## Author response to reviewer 1

The manuscript describes the calibration of two of the three model components that constitute the DWM model and the comparison of the full model result to wake flow measurements. Data base for calibration are measurements from a SpinnerLidar in the wake field of one of the V27 wind turbines at the SWIFT facility. Three different scanning strategies are applied to collect different kind of flow field representation. The total amount of collected scans comprises roughly 142 hours that are sorted in three different atmospheric stability classes. By means of Bayesian inference the model parameters of two of the model components of the DWM model, the deficit in the meandering frame of reference and the wake-added turbulence model are calculated. The methodology allows for a calculation of an uncertainty of the parameters established from a probability distribution. The authors show and discuss the results of the parameter fitting also in comparison to other calibration studies of the DWM model. The final evaluation is conducted by comparing the full DWM implementation with the calibrated submodels to a subset of measurements. The manuscript is in genera

Figure 1: A schematic view of the SpinnerLidar's scanning pattern: (a) a front-view at 2.5D in the wake, (b) a top-view including all scanned distances behind the *WTGa1*, which is depicted in solid blue lines. The *WTGa2* is also shown.

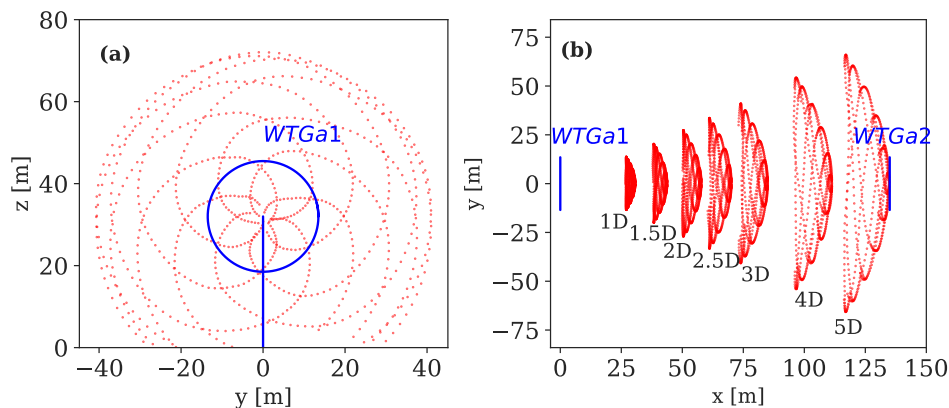
24. Figure 1: Is the position of *WTGa2* correct? In the description, it states that in strategy III a Lidar scan is performed at 5D behind the rotor. This would mean that the Lidar scan is performed at the same position where *WTGa2* is located

We re-plotted Fig. 2 (in the manuscript) showing all the 7 scanned distances by the SpinnerLidar from a top view (see Fig. 1 below). Assuming that *WTGa1* and *WTGa2* are perfectly aligned during operation, then the central points of the rosette pattern are nearly at the same position of *WTGa2*. However, as the lidar scans within a sphere and the two turbines are rarely aligned, the scan is performed a few meters in front of *WTGa2*. Nevertheless, as described in Ln. 326 and also in Herges et al., 2019 [15], we discard invalid measurements that occur due to the return from the rotating rotor of *WTGa2*, among others.
